Amendment 002

Fuel Storage System Upgrades Terra Nova National Park (TNNP) NL

EA003-211642/A

Addendum NO1

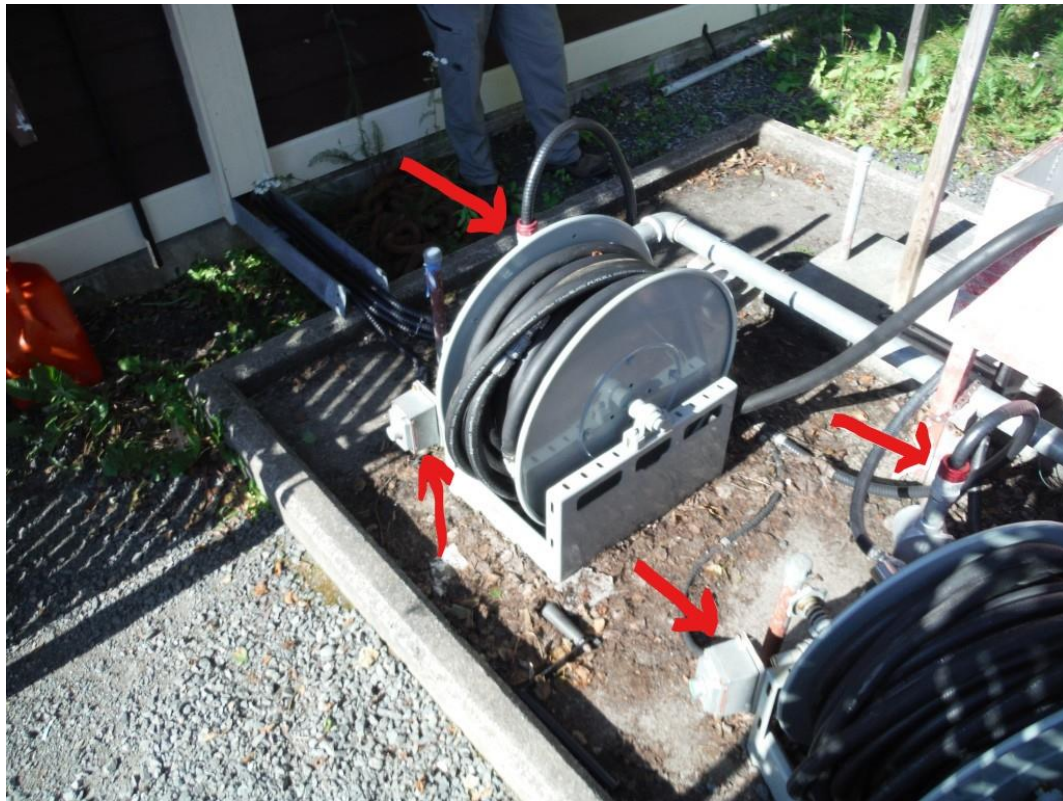
Question #8: (Wharf) On drawing M-4 there seems to be some electrical connection points that do not exist at this time and I have attached a sketch of the points that I would like to have clarified.

Answer #8: The identified electrical connection points are existing, and are identified in the attached site photograph. **Shown at the bottom of this document

TANK GROUNDING
DETAIL

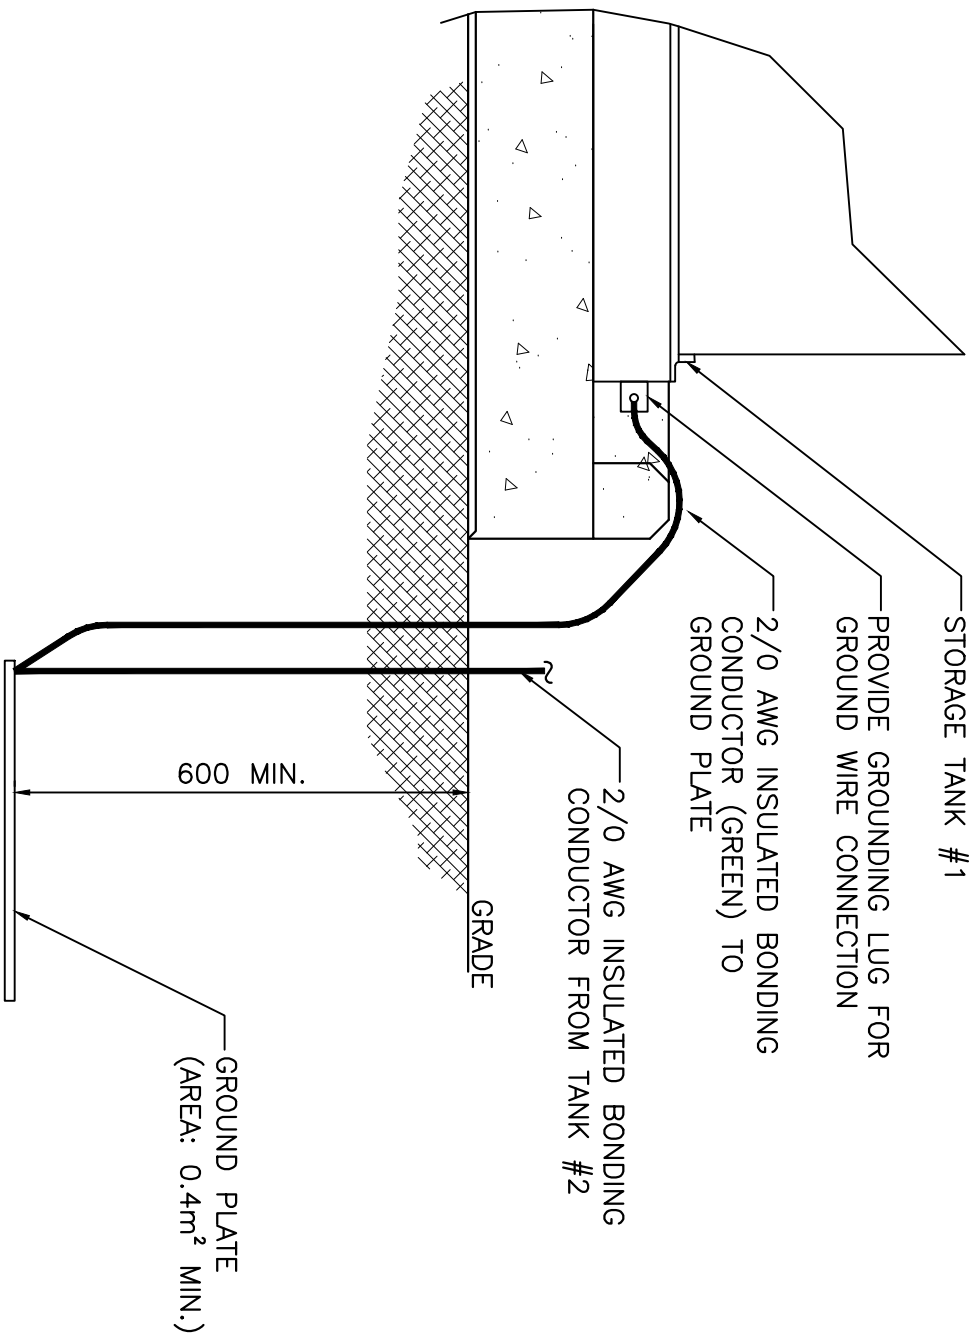
Question #6: (Wharf) There is a new grounding plate shown on the plans for the two fuel tanks, do you have specification for this plate and to what depth do we bury it (below the low water level)?

Answer #6: The new grounding plate is to be minimum 0.4m² in area, and is to be installed minimum 600mm below finished grade, in accordance with the requirements of the Canadian Electrical Code. Please see attached tank grounding detail. **Shown at the bottom of this document
